**Report Type:** SSDA Access Report

**Client:** Al Faisal College, Liverpool

**Site Address:** West Avenue and Gurner Avenue (Secondary School) and  
Fourth Avenue and Gurner Avenue (primary school)  
Austral NSW

# ACCESS REPORT

### Primary School

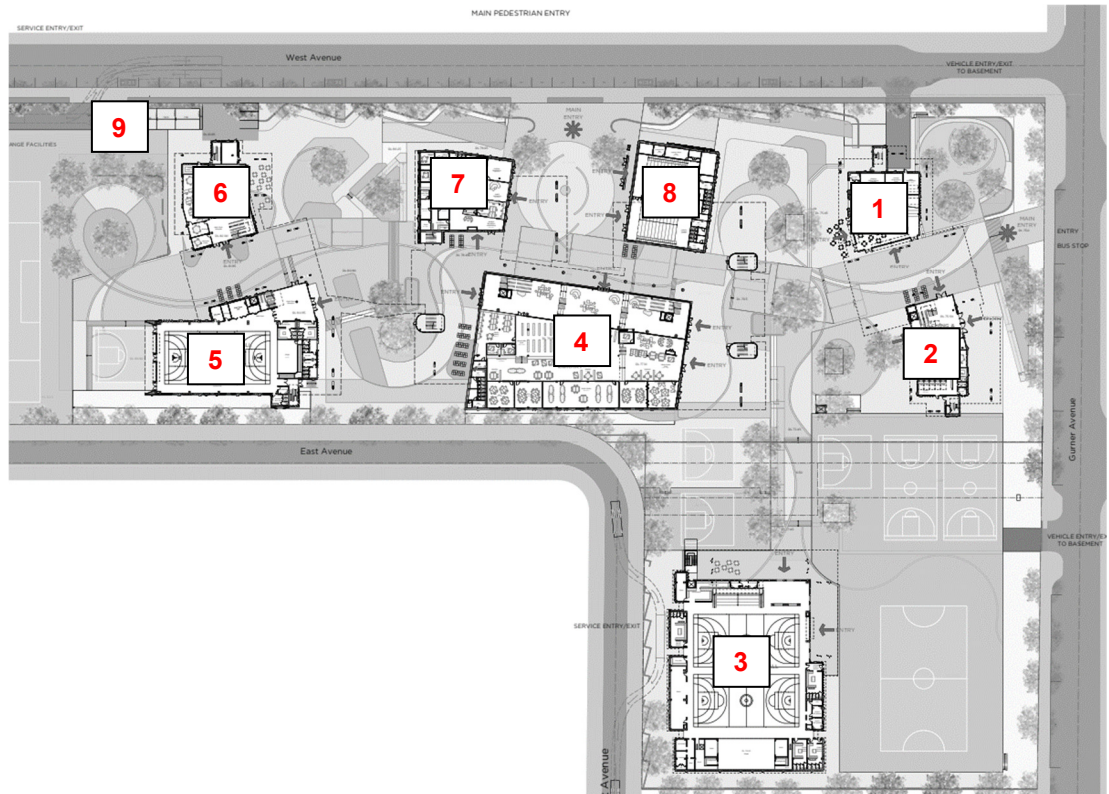
- 50% of the pedestrian entry points are required to be accessible with no more than 50M in between the accessible and non-accessible entry point. This would require to be detailed at the CC stage of works to ensure that stepped entry is provided with a lift for accessibility
- Accessible parking spaces have not been indicated on plans for this component, however, can be easily incorporated at the CC stage of works
- Good interlinkages have been provided with ramps throughout the building.
- Adequate Accessible toilets have been provided and some detailing will be required to ensure an even mix of LH and RH transfer toilets in each building as well as cumulatively in the Primary School
- Toilets in addition to the Accessible toilets have the capacity to be designed as Ambulant toilets with further detailing at CC stage of works.

## Secondary School

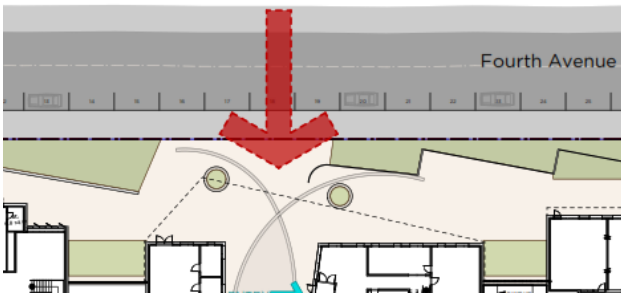
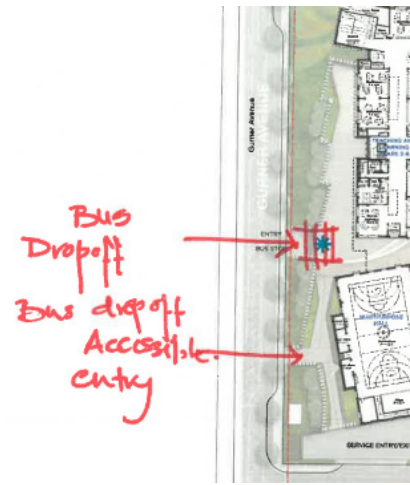
- All pedestrian entries have been designed as being accessible
- Accessible parking spaces been provided with close proximity to the lifts.
- Detailing will be required to provide step free interlinkages in between the buildings on the ground floor level.
- Adequate Accessible toilets have been provided in majority of the buildings and some detailing will be required to ensure an even mix of LH and RH transfer toilets in each building as well as cumulatively in the Secondary School
- Toilets in addition to the Accessible toilets have the capacity to be designed as Ambulant toilets with further detailing at CC stage of works.

## Secondary School

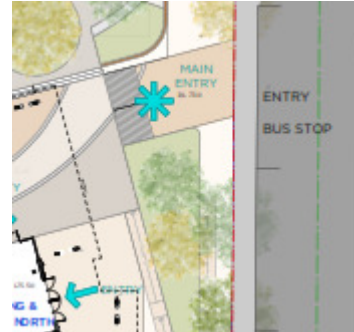
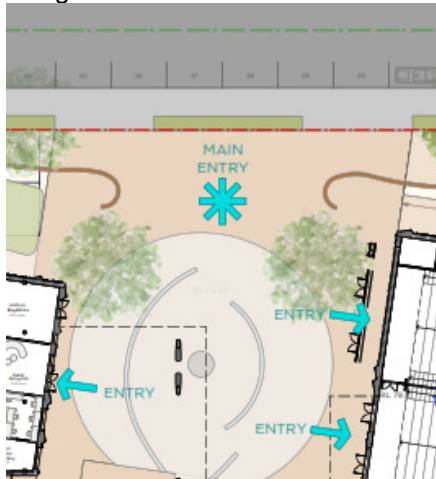
The plans indicate 2 pedestrian entrances to the Secondary school, both of which are designed to be accessible.

Details to be verified at CC stage of works.

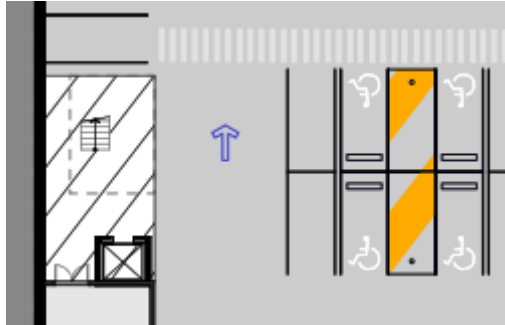
<b>Compliance Comments</b>	Capable of compliance. Currently no accessible parking spaces have been indicated on the plans for the Primary School and 9 Accessible parking spaces have been indicated in the Secondary school .  Both Primary and Secondary school require one accessible car parking space to be provided per 100 car parking spaces allocated to Class 9b component.  The total number of Accessible parking spaces required will be determined with each stage of the development. Detailed features of the accessible parking space to be verified at CC stage of works.

### Building 3: Multipurpose hall

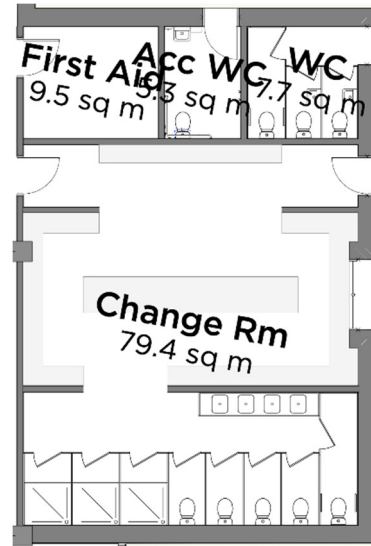
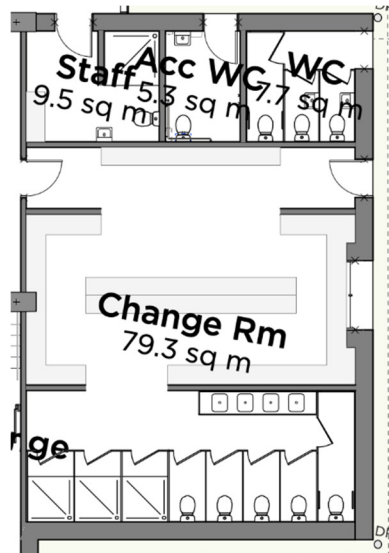
Ground floor: 1 Unisex accessible LH transfer toilet and 1 Unisex accessible RH transfer toilet (to be provided for an even mix). Staff will have also require an accessible WC (no wall permitted to shower)

Ambulant toilets have been indicated and accessible toilets provided for students to be redesigned to incorporate an accessible shower as standard showers have been provided for use of students.

### Building 4: Years 3 – 6 Central

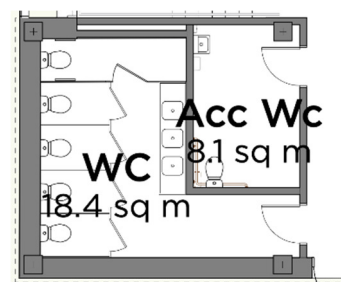
Ground floor: 1 Unisex accessible LH transfer toilet

First floor : 1 Unisex accessible RH transfer toilet to be provided (to provide an even mix in each building)

Ambulant toilets will be required in each bank of toilets at the CC stage of works. These can be easily accommodated as shown below.

#### Building 8: Admin

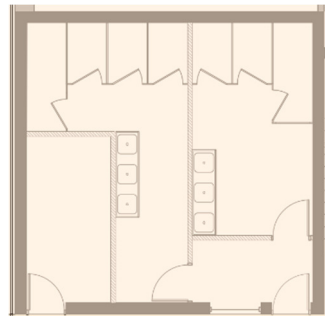
The accessible toilet has not been indicated and provision of either an LH or RH transfer unisex accessible toilet will be suitable in this location (subject to overall even mix of LH / RH)

The accessible toilet and male and female ambulant toilet to be detailed at CC stage of works.

#### Building 4: Library

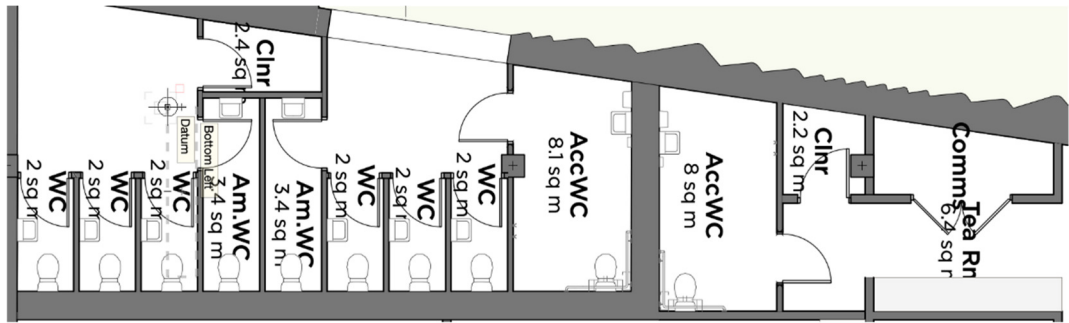
Ground floor: 1 Unisex accessible RH transfer toilet and 1 Unisex accessible LH transfer toilet

Ambulant toilets to be detailed at the CC stage of works.

#### HUB Building

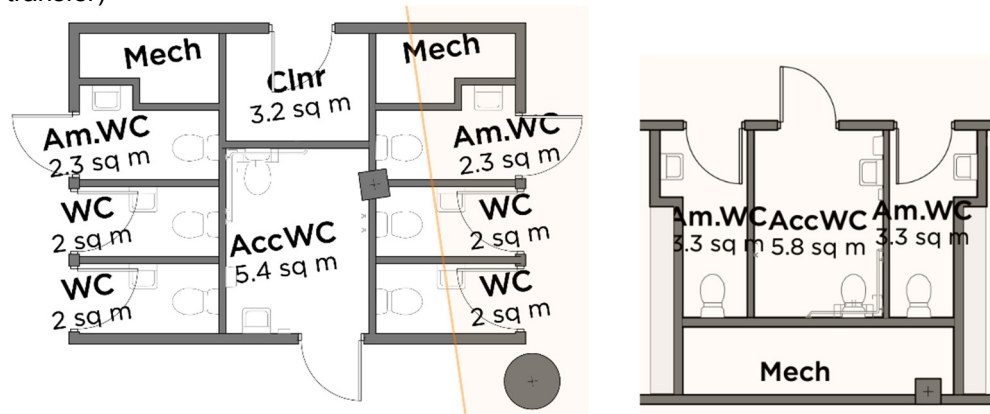
Accessible toilet with Male and female ambulant toilets provided. At CC stage an even mix of LH and RH transfer accessible toilets will be required (at this point both are shown as RH transfer)

#### Building 6: Teaching and Learning North Facing West Avenue

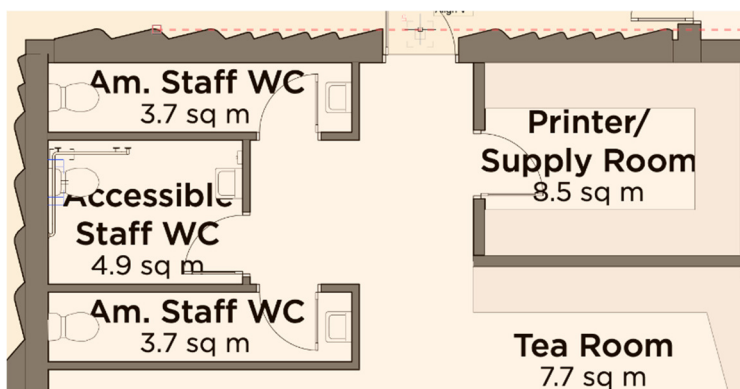
Ground floor: 1 unisex accessible LH transfer toilet and 1 male and 1 female ambulant toilet is provided.

### Building 7: Admin

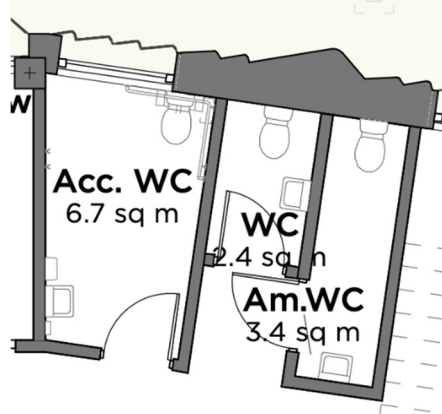
Ground floor: 1 Unisex accessible LH transfer toilet has been provided. The other toilets are to be detailed as male and female ambulant toilets at the CC stage of works.

### Building 8: Lecture Theatre

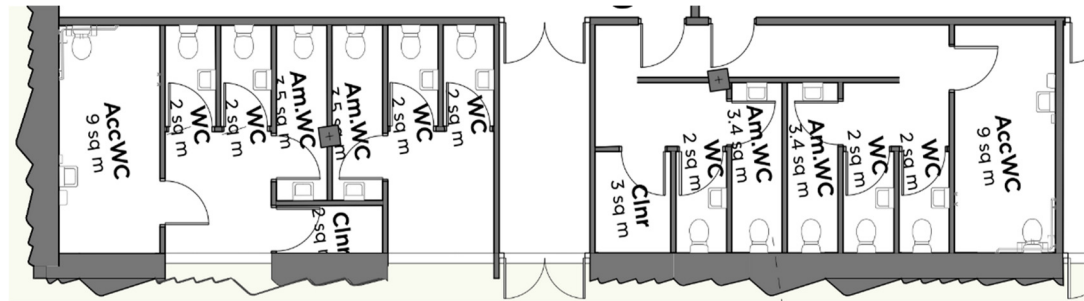
Ground floor: 2 Unisex accessible RH transfer toilets have been provided and one of these is required to be redesigned for LH transfer (to provide an even mix in each building)

### Building 9: Ancillary

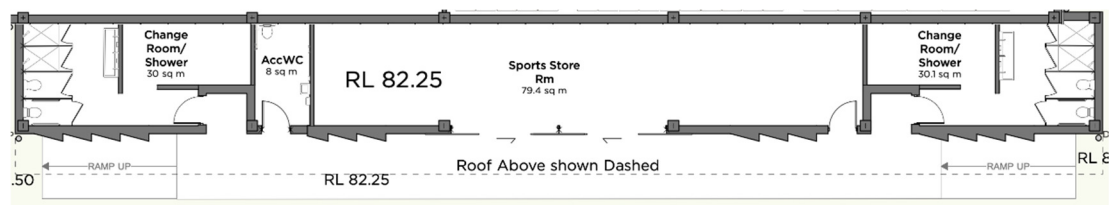
1 Unisex accessible RH transfer toilet has been provided. This toilet is required to be redesigned to include an accessible shower as standard showers have been provided. Ambulant toilets are provided and to be detailed at the CC stage of works.
